HISTORIC AND DESIGN REVIEW COMMISSION

HDRC CASE NO: 2015-476
COMMON NAME: 227 4TH ST
ADDRESS: 207 4TH ST
213 4TH ST
219 4TH ST
223 4TH ST
120 TAYLOR ST
118 TAYLOR ST
LEGAL DESCRIPTION: NCB 430 BLK 8 LOT 5 & 6
NCB 430 BLK 8 LOT 3 & 4
NCB 430 BLK 8 LOT 2
NCB 430 BLK 8 LOT 1
NCB 430 BLK 8 LOT 7
NCB 430 BLK 8 LOT 8
ZONING: D RIO-3, D HL RIO-3
CITY COUNCIL DIST.: 1
LANDMARK: Null
APPLICANT: Joseph Straube/Marmon Mok Architecture
OWNER: Tobin Center for the Performing Arts
TYPE OF WORK: Final approval of a parking garage
REQUEST:

TOBIN CENTER FOR THE PERFORMING ARTS
PARKING GARAGE

Historic and Design Review Commission
Design Review Committee
Report & Recommendation

Outdoor Seating Concept

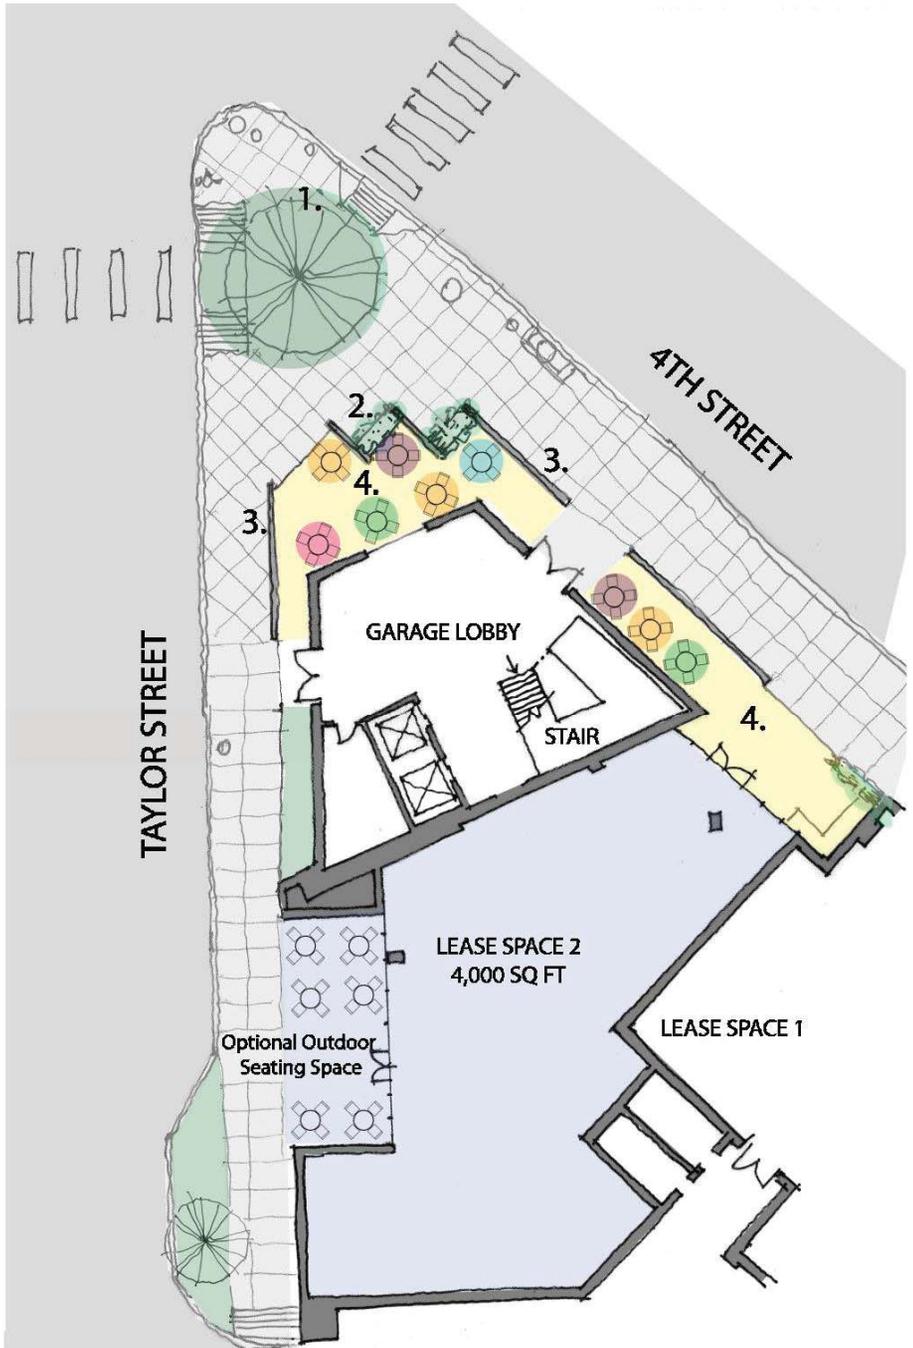
- a. This request received conceptual approval from the HDRC on June 18, 2014.
- b. This request was reviewed by the Design Review Committee on January 26, 2016. At that meeting, the committee was generally satisfied with the selection of materials, but requested additional rendered views to verify that the proposed screening would be adequate. It was noted that the design responded to the existing street conditions and that the façade along Taylor Street was well articulated. The committee requested additional information regarding the lighting of the structure and how the roof deck would be lit. For example, the locations of the exterior fixtures specified in the exhibits are not called out in the construction documents. The committee was also interested in seeing a developed landscaping plan to better understand the final conditions along the pedestrian walkway.

JL: landscape fictional or what's to be implemented?

Exterior Building Elevations

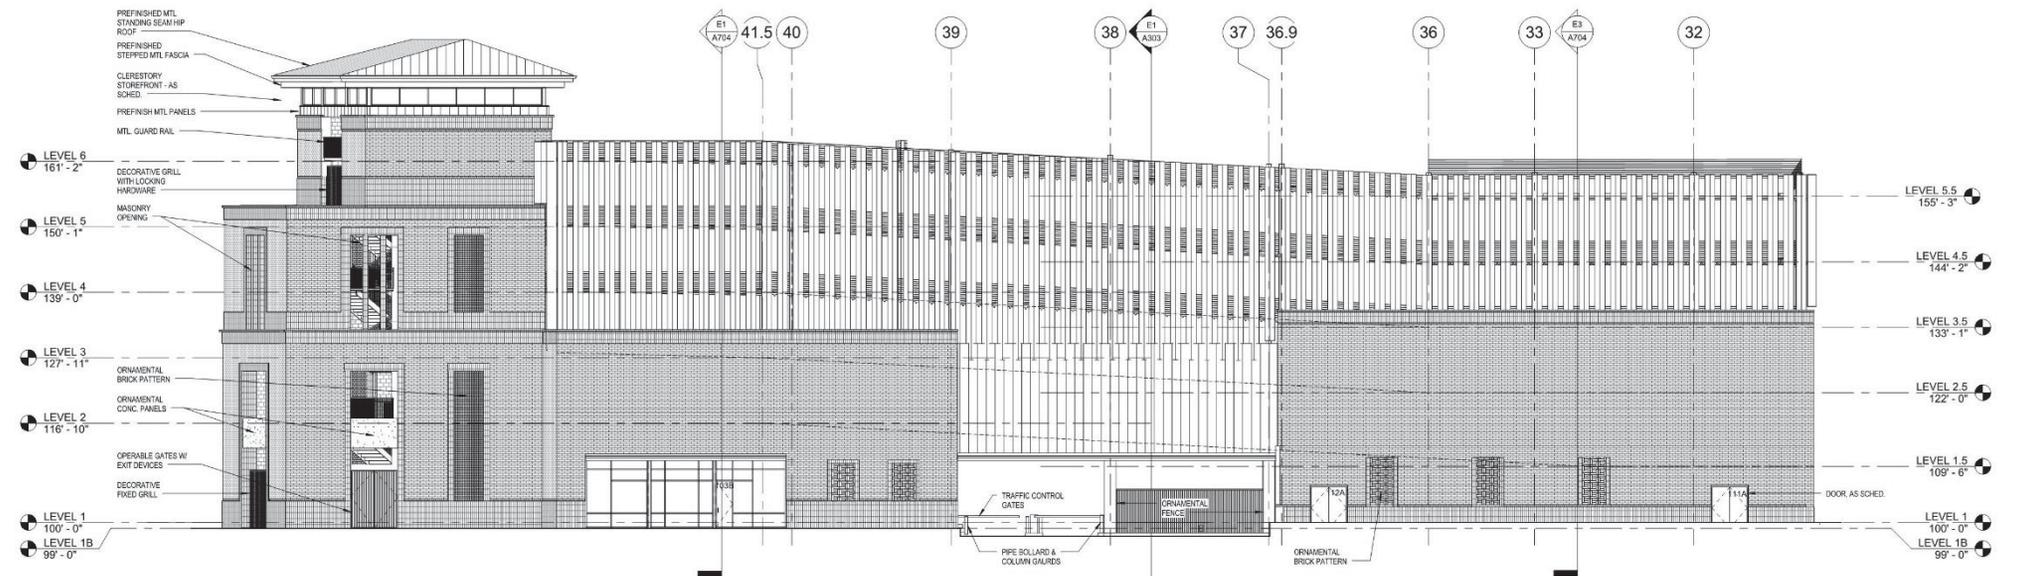
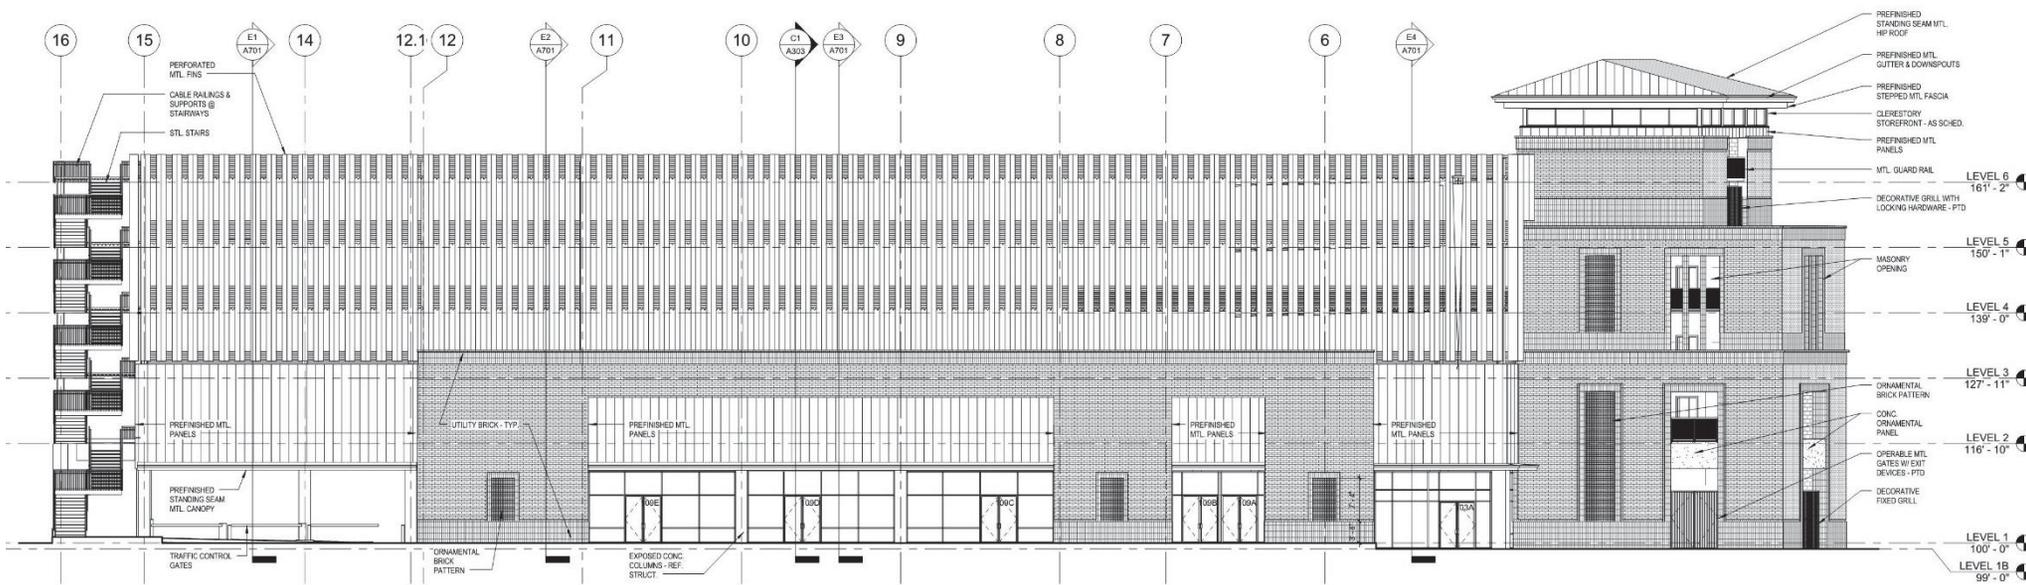
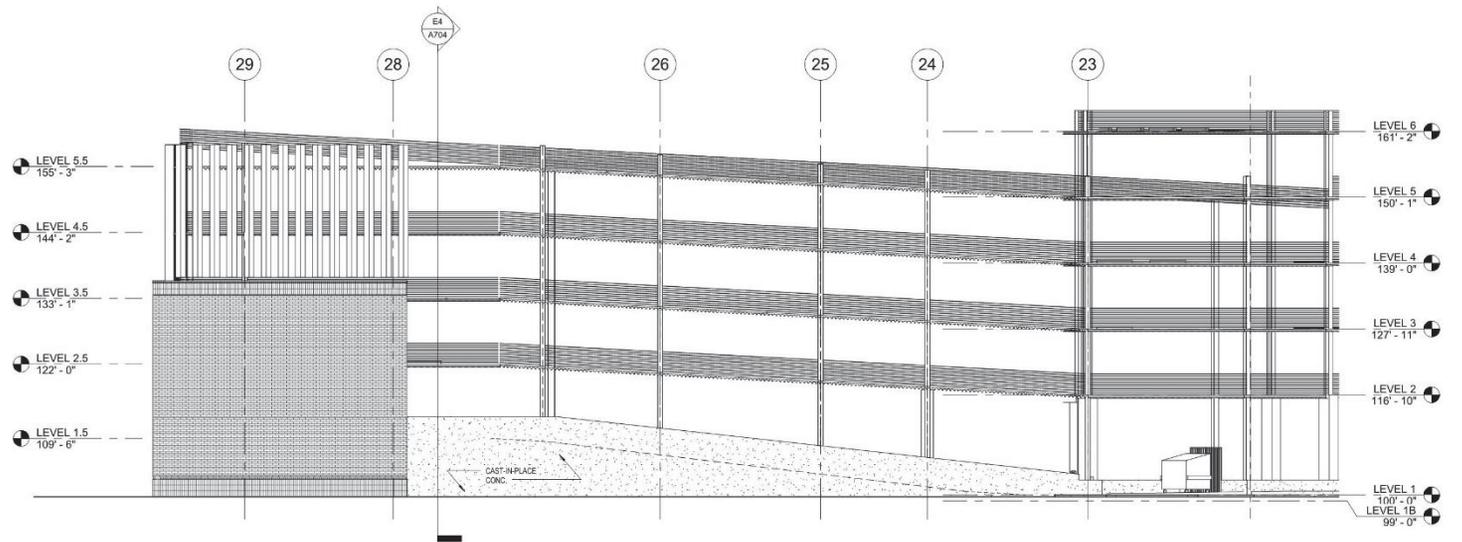
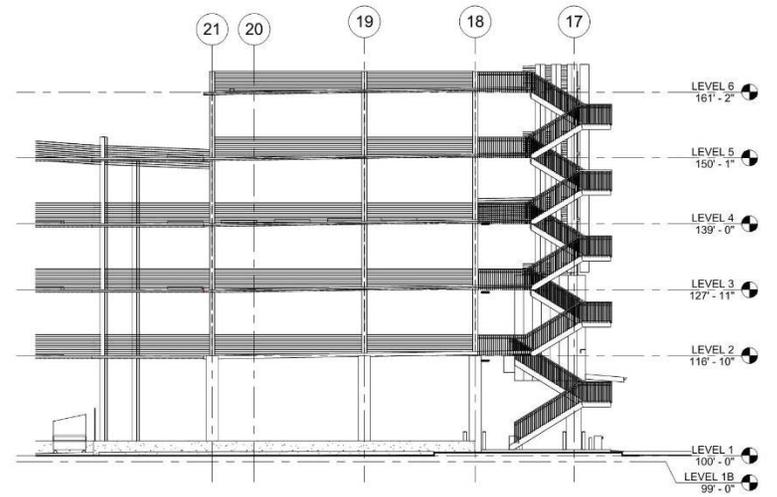
COMMENTS/CONCERNS: MG: How many spaces? EAST
ELEVATION, who is the immediate neighbor? Steve: alley,
brick wall/parking lot, MG: Want to make other
commissioners understand cannot see from east. create
perspective. show why don't need more screening.

NOTE REVISIONS REQUESTED FOR VIEW

OF EAST ELEVATION, LIGHTING DIAGRAM @ TOP DECK

Exterior Garage Pole Lights at Level 6

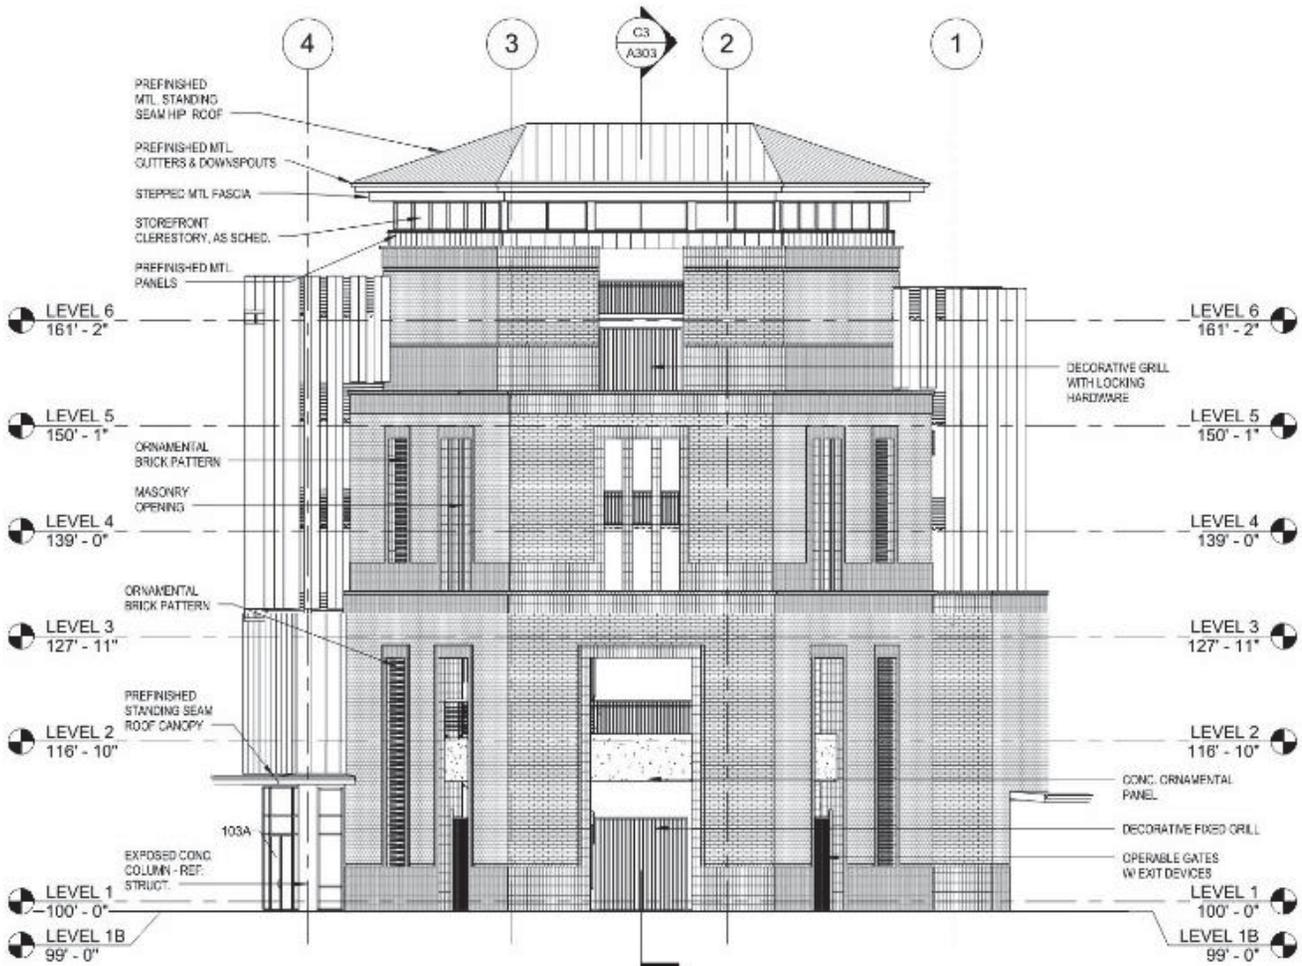
MG: RECAPED materials elegant. Articulation on Fayon. How
is top deck lit? Poles on inside. Provide diagram. What's
vs edge of top
use of Light well? Answer how visible this is, especially at night?
What's the path to Tobin? →
